Sigma Phi Epsilon | University of Washington
 4637 21st Ave NE, Seattle, Washington
 05.06.20 Design Review Board Package

MUP# 3032696-EG, 3030739-LU

BOARD RECOMMENDATIONS AND RESPONSES

CURRENT EXTERIOR VS PREVIOUS

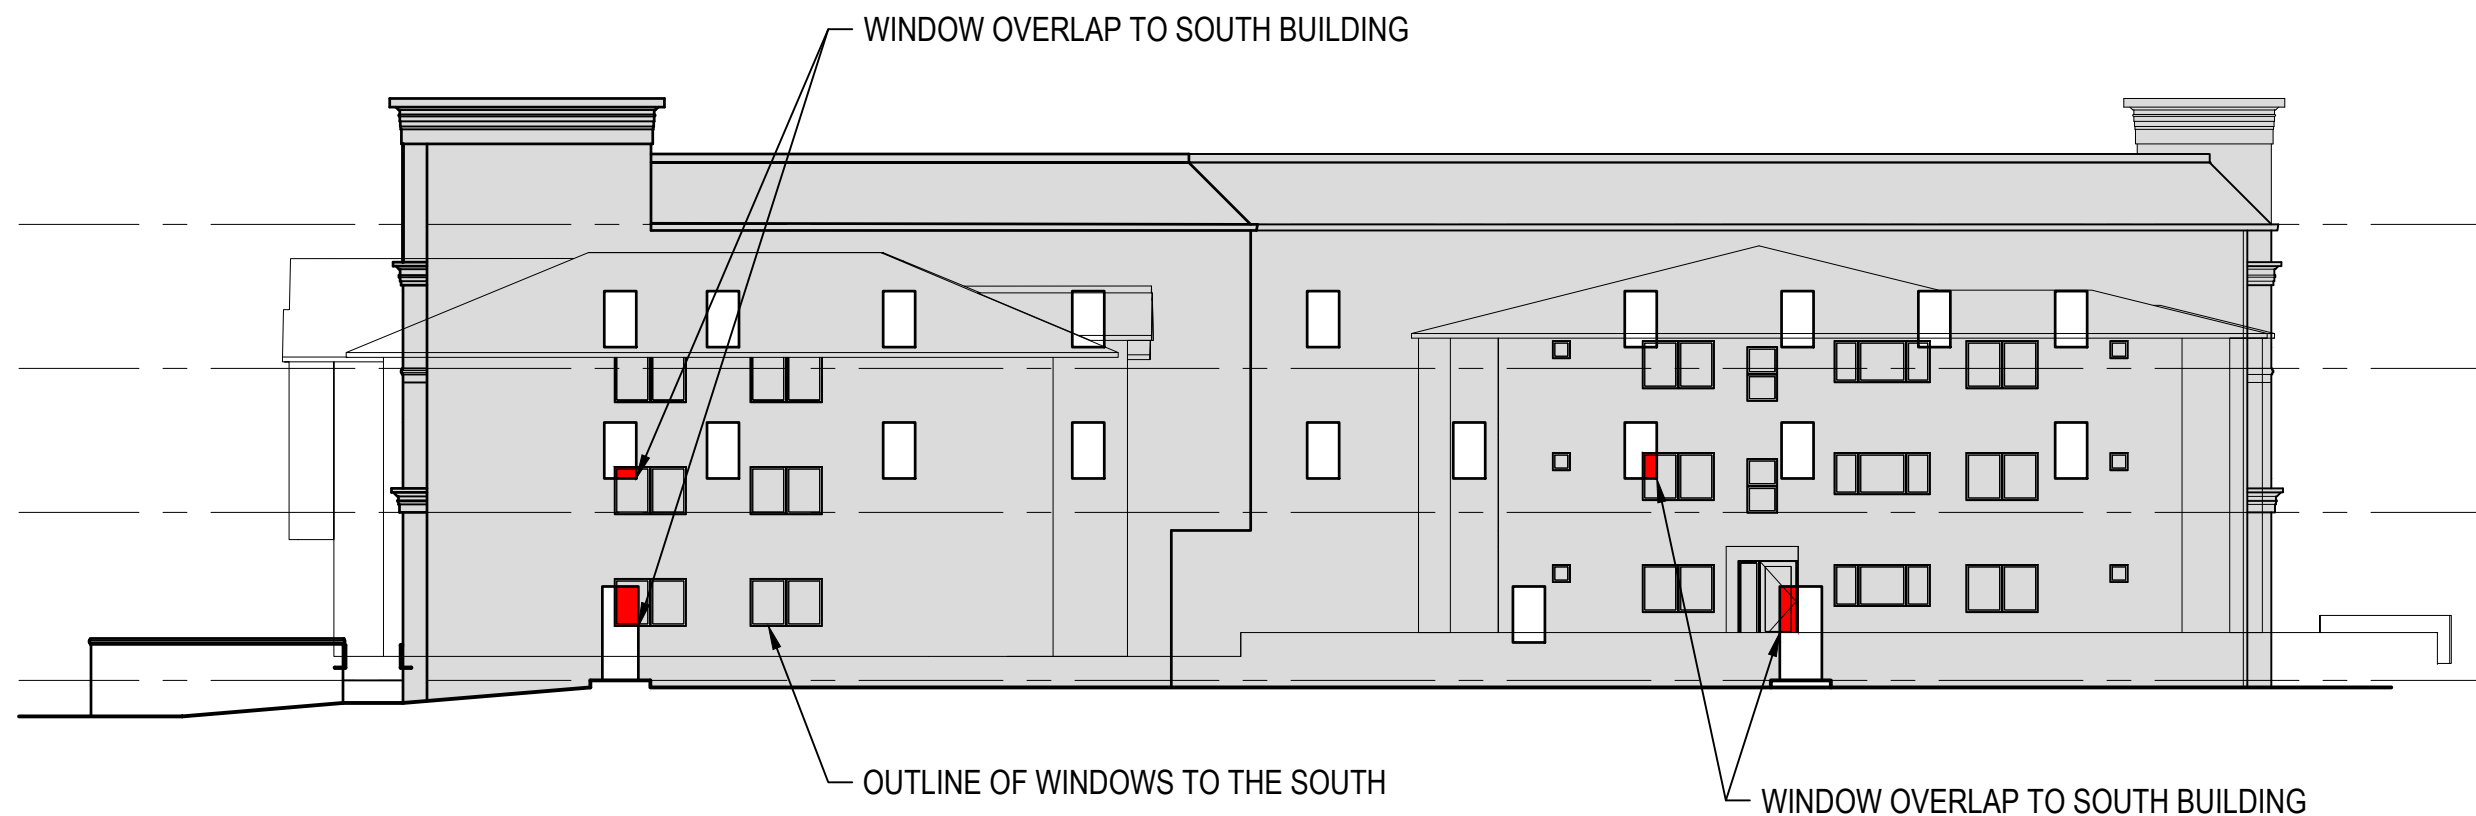
- a. The Board unanimously agreed that the shape of the site and the setbacks made development challenging and that the applicants preferred scheme seemed to best meet the design guidelines. (CS1, CS2, DC1, DC2, and DC3) - **The shape and setbacks of the building have maintained the preferred scheme shown at EDG while including more exterior usable area (East Patio)**

- c. A Board member warned, and others agreed, that when working within a formal vocabulary of windows and details even minor deviations from the rigor expressed in the design becomes very apparent and could erode the strength of the concept. Specific caution was given to the treatment of the bike room and its window. (DC1, DC2, PL2 and PL4) - **We have relocated the bike room to the rear for privacy and security of the residents. A stairwell is at the NE corner of the property that will add an anchor presence to the building and adds strength to the design concept..**

- d. The Board discussed the classically inspired shape of the building and acknowledged that symmetry is critical to its success. That said, the Board wanted to ensure the applicant that understood that perfect symmetry would not be required for the design concept to be successful. However, deviations from the symmetrical design should be well detailed, intentional and explained in future submittals. (CS3, PL1, DC1, and DC3) - **The new design of the building falls back to the traditional residential feel while maintaining symmetry and uniqueness that is garnered from the lot layout and a desire to provide ground-level amenity area.**

- e. The Board further appreciated the traditional character of the building, the use of brick noted in the design review packet, and the broad overhang that is central to the design. - **The new design of the exterior maintains the brick and has added more cast stone to accompany it. The Entrance overhang and scale has been increased for a stronger perceptive entrance and character.**

- b. The Board discussed the entry at length. They agreed it was the focus of the project and a strong form but needed more detail and refinement. The Board reiterated their support for its broad overhang and even suggested pulling the overhang and its columns further toward the sidewalk, indicating they would support a departure if it's necessary to achieve this goal. (PL2, PL3 and DC2) - **The new design is slightly less in length and includes the east patio. The entrance has been moved further towards the sidewalk to give the entrance a smoother transition.**

1. Patio was added to the East end of the building. This added exterior space for the residents will provide an exterior gathering space to the building. It will be surrounded by shrubbery and greenery between that and the sidewalk. Pony walls are added to accommodate the grade change and for seating.

2. The Contemporary/modern horizontal roof line has been replaced with a more traditional sloped and shingled Mansard roof. This will bring a classical collegiate feel to the facade and residence.

3. The Residential levels at the 2nd and 3rd floors of the exterior elevations, bring a time honored feel with a classic brick face and cast stone window surrounds. Shutters are also to be added.

4. Cast Stone is being used on the first level of the residence. This brings a high class persona and level of durability to the facade. Cast stone is a notably historic use and classic gesture to the timeless quality the traditional look of this building deserves.

5. The Entrance to the building continues the cast stone feel of the first level. Six cast stone columns are being used to bring some broadness and presence to the entrance. The 3rd level has a cast stone balcony that will overlook 47th street.

1 DEPARTURE PLAN
SCALE: 1/16" = 1'-0"

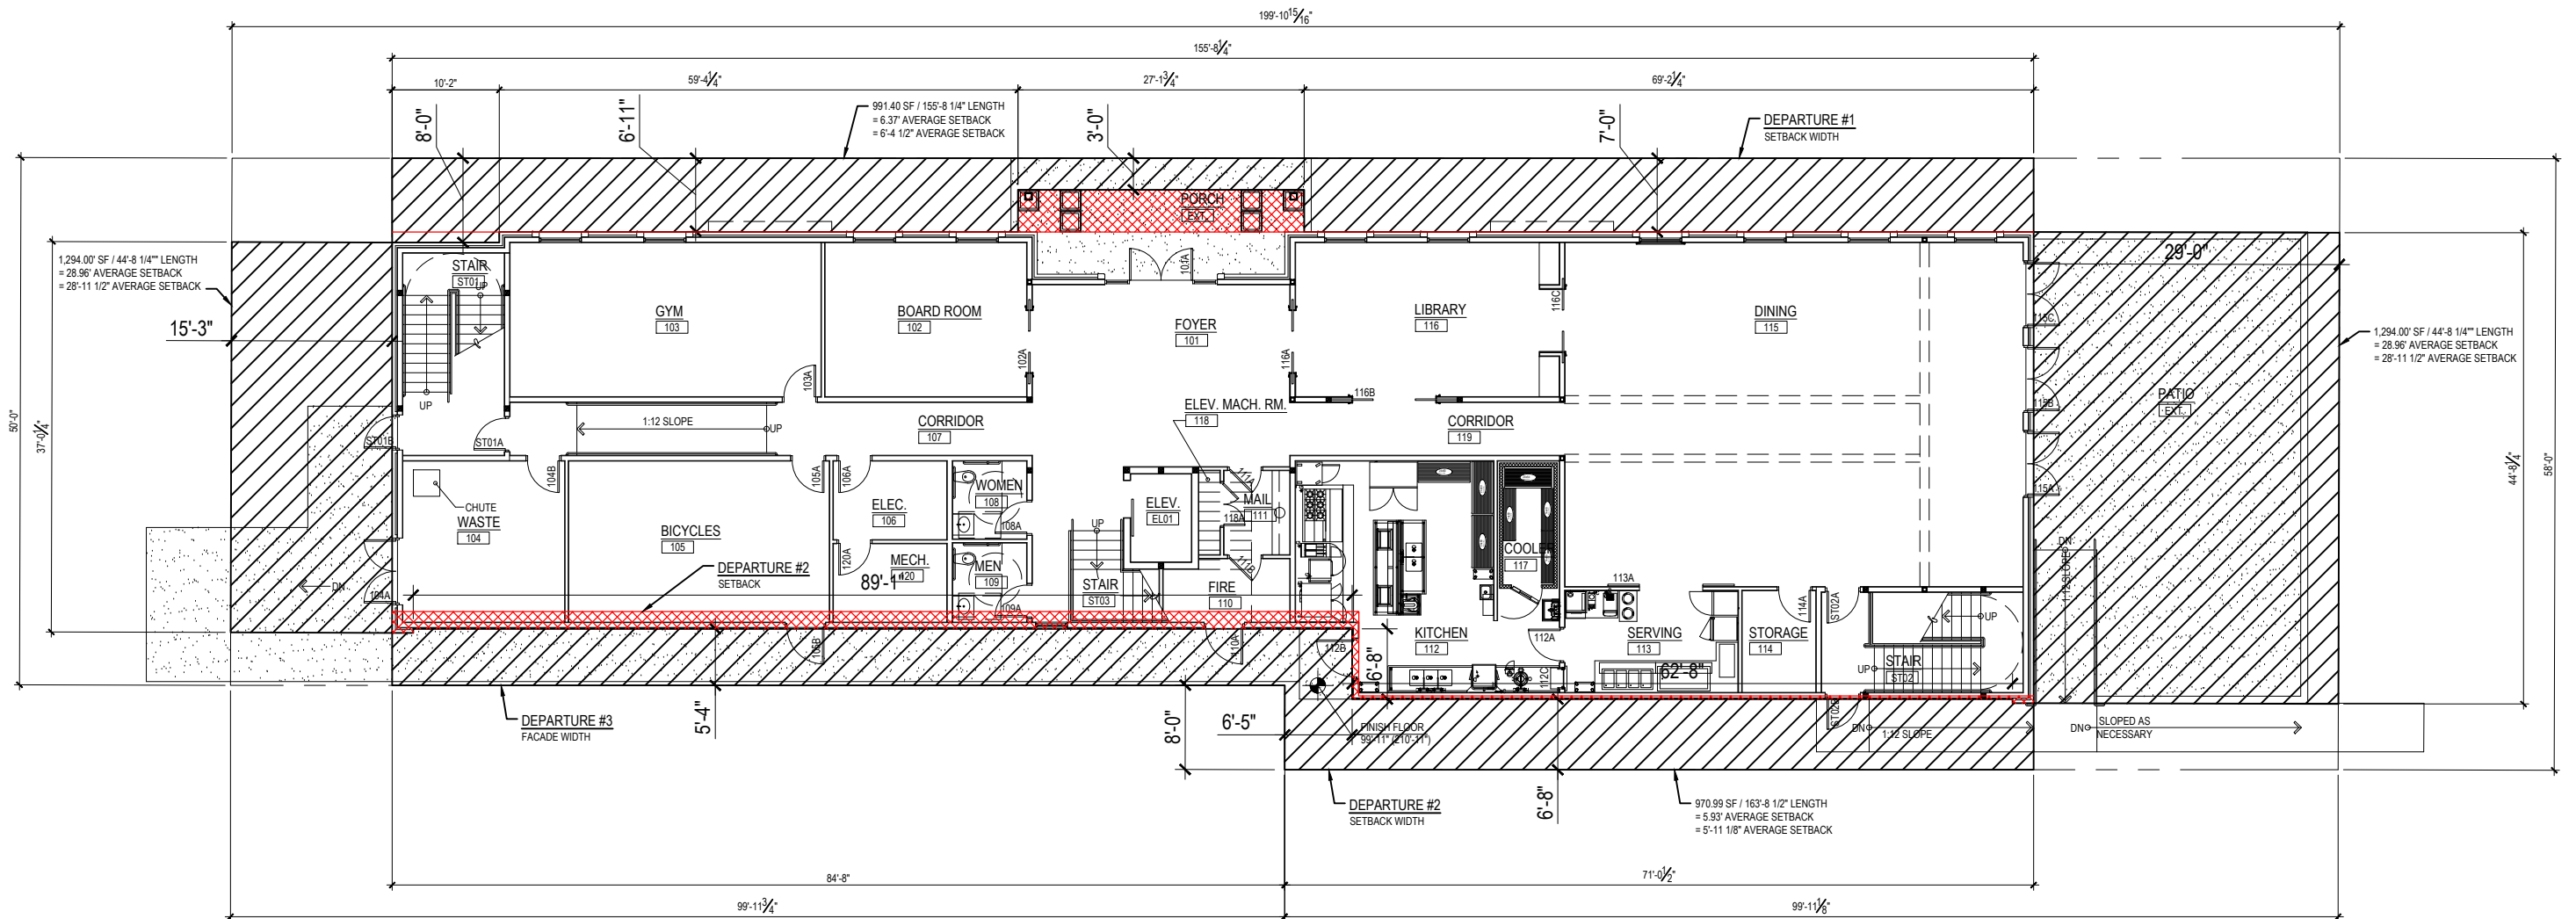
1. Setbacks and Separations (23.45.518.A): The Code requires a side setback for facades greater than 40 feet must be a 7' average and a 5' minimum. The applicant proposes an average of 5' to 7' and an min. of 3'.

The Board indicated preliminary support for this departure. The departure allows the portico columns at the entry feature which is critical to the success of the traditional styling and symmetrical massing of the project. This feature clearly marks the entrance along NE 47th St and is a response to the context of nearby fraternity/sorority buildings. (CS2.A2, CS2.B2, CS3.A1, PL3.A2, and DC2.B1) - **This setback is still requested with the new design of the building, while minimum maintains true to the portico and columns.**

2. Structure Width & Facade Length (23.45.527.B.1): The Code requires that the combined length of all portions of the façade within 15 feet of a lot line shall not exceed 65% of the length of the lot line. The applicant proposes to allow the combined length of all portions of the facades within 15' be equal to 68% of the length of the lot line.

The Board indicated preliminary support for this departure. The small departure allows a larger amenity area and pushes a tall piece of building structure away from the more visible facades of the building, which improves the streetscape. (CS2.A2, CS2.C3, CS3.A1, DC2.B1, DC2.D1) - **This setback is still requested with the new design of the building.**

3. Side setbacks for Facades Greater than 40' (23.45.518.A) The Code requires that the side setback for facades greater than 40' in length must be 7' average and 5' minimum. The applicant proposes a 6.25' average setback and to maintain the minimum of 5' at the south of the site.

The Board indicated support for this departure. It allows from the larger entry area supported by the Board and allows for a more articulated front façade. (CS2.A2, CS2.B2, CS3.A1, PLC.B3) - **This setback is still requested with the new design of the building.**

4. Structure Width & Facade Length (24.35.527.B.1) The code states that a maximum combined length of all portions of the facades within 15 feet of a lot line that is neither a rear lot line or a street or alley lot line shall not exceed 65% of the length of that lot line. The applicant is requesting that they be equal to 95% as illustrated on page 35 of the design review packet.

The Board indicated preliminary support for this departure. The gesture allowed for and is offset by the generous entry courtyard at the north street facing side of the property. (CS2.A2, CS2.B2, CS3.A1, PLC.B3) - **This setback is still requested with the new design of the building.**

| DEPARTURE REQUEST | CODE | STANDARD | PROPOSED | RATIONALE | RELATED GUIDELINE | CALCULATION | % CHANGE FROM STANDARD | RECOMMENDATION |
|-------------------|--|---|--|---|--|--|--|---------------------------------|
| 1 | 23.45.518.A SIDE SETBACKS & SEPARATIONS | SIDE SETBACK FOR FACADES GREATER THAN 40 FEET IN LENGTH MUST BE 7' AVERAGE; 5' MINIMUM | REQUEST TO DEPART FROM THE 7' AVERAGE SETBACK. ALLOW AN AVERAGE SIDE SETBACK OF 6'-0". MAINTAIN THE MINIMUM SIDE SETBACK OF 5'-0" | <p>THE LARGE PORTICO ON THE NORTH FACE CLEARLY MARKS THE ENTRANCE TO THE BUILDING WHILE PROVIDING WEATHER PROTECTION AT THE ENTRY. THE COLUMNS IN THE PORTICO ARE AN ARCHITECTURALLY CONTEXTUAL ELEMENT TYPICAL OF BUILDINGS IN THE GREEK SYSTEM.</p> <p>PER 23.45.518.H1, "Cornices, eaves, gutters, roofs, and other forms of weather protection may project into required setbacks and separations a maximum of 4 feet if they are no closer than 3 feet to any lot line". THIS PORTICO WOULD BE CONSIDERED A ROOF PROJECTION AND BE CODE COMPLIANT.</p> | CS2.A2 - ARCHITECTURAL PRESENCE CS2.B2 - CONNECTION TO THE STREET CS2.C3 - FULL BLOCK SITES PL1.C3 - YEAR-ROUND ACTIVITY CS3.A1 - FITTING OLD AND NEW TOGETHER PL3.A2- ENSEMBLE OF ELEMENTS DC2.B1 - FACADE COMPOSITION DC2.D1- HUMAN SCALE DC3.A1 - INTERIOR/EXTERIOR FIT DC3.B4 - MULTIFAMILY OPEN SPACE | 991.40 SF / 155'-8 1/4" LENGTH = 6.37' AVERAGE SETBACK = 6'-4 1/2" AVERAGE SETBACK | (7' - 6.37') / 7' = 9 % CHANGE (5' - 3') / 5' = 40 % CHANGE | DRB RECOMMENDED APPROVAL AT EDG |
| 2 | 23.45.518.A SIDE SETBACK FOR FACADES GREATER THAN 40' | SIDE SETBACK FOR FACADES GREATER THAN 40 FEET IN LENGTH MUST BE 7' AVERAGE; 5' MINIMUM. | REQUEST TO DEPART FROM THE 7' AVERAGE SETBACK. ALLOW AN AVERAGE SIDE SETBACK OF 5'-11". MAINTAIN THE 5' MINIMUM. | PROVIDING A MODERATE DEPARTURE AT THE SOUTH PROPERTY LINE WILL ALLOW AN APPROPRIATE EGRESS ROUTE AS WELL AS PLACE THE BUILDING IN A BALANCED POSITION ACROSS THE WHOLE LOT. THIS WILL STILL MEET THE MINIMUM OF A 5' SETBACK. | CS2.A2 - ARCHITECTURAL PRESENCE CS2.B2 - CONNECTION TO THE STREET CS2.C3 - FULL BLOCK SITES CS3.A1 - FITTING OLD AND NEW TOGETHER PL1.C3 - YEAR-ROUND ACTIVITY PL2.B3- STREET-LEVEL TRANSPARENCY PL3.A2- ENSEMBLE OF ELEMENTS DC2.B1 - FACADE COMPOSITION DC2.D1- HUMAN SCALE DC3.A1 - INTERIOR/EXTERIOR FIT DC3.B4 - MULTIFAMILY OPEN SPACE | 970.99 SF / 163'-8 1/2" LENGTH = 5.93' AVERAGE SETBACK = 5'-11 1/8" AVERAGE SETBACK | (7' - 5.93') / 7' = 15 % CHANGE | DRB RECOMMENDED APPROVAL AT EDG |
| 3 | 23.45.527.B.1 STRUCTURE WIDTH & FACADE LENGTH | THE MAXIMUM COMBINED LENGTH OF ALL PORTIONS OF THE FACADES WITHIN 15 FEET OF A LOT LINE THAT IS NEITHER A REAR LOT LINE NOR A STREET OR ALLEY LOT LINE SHALL NOT EXCEED 65% OF THE LENGTH OF THAT LOT LINE. | REQUEST TO DEPART FROM THE MAXIMUM 65% RATIO FOR THE LENGTH OF THE BUILDING ALONG THE SIDE SOUTH PROPERTY LINE. ALLOW THE COMBINED LENGTH OF ALL PORTIONS OF THE FACADES WITHIN 15' TO EQUAL 71.16' OF THE LENGTH OF THE LOT LINE. | PROVIDING A MODERATE DEPARTURE ALONG THE SOUTHERN PROPERTY LINE ALLOWS THE BUILDING TO BE LONGER ALONG THIS NON-STREET LOT LINE, RUN THE LENGTH OF THIS NARROW LOT, AND ALLOW FOR A GENEROUS ENTRY COURTYARD AND CENTRAL COMMON SPACE ON THE FIRST FLOOR BALANCED WITH APPROPRIATELY-SIZED OPEN SPACES AT THE EAST AND WEST ENDS OF THE PROPERTY. THE AMOUNT OF THE DEPARTURE HAS BEEN REDUCED BY NEARLY 19% FROM THE EDG MEETING." | CS2.A2 - ARCHITECTURAL PRESENCE CS2.B2 - CONNECTION TO THE STREET CS2.C3 - FULL BLOCK SITES CS3.A1 - FITTING OLD AND NEW TOGETHER PL1.C3 - YEAR-ROUND ACTIVITY PL2.B3- STREET-LEVEL TRANSPARENCY PL3.A2- ENSEMBLE OF ELEMENTS DC2.B1 - FACADE COMPOSITION DC2.D1- HUMAN SCALE DC3.A1 - INTERIOR/EXTERIOR FIT DC3.B4 - MULTIFAMILY OPEN SPACE | (89'-0 5/8" + 6'-8" + 62'-7 5/8") / (99'-11 1/8" + 8'-0" + 99'-11 3/4") = 158.35' / 207.91' = 76.16% | (76.16% - 65%) / 65% = 17.17% INCREASE | DRB RECOMMENDED APPROVAL AT EDG |
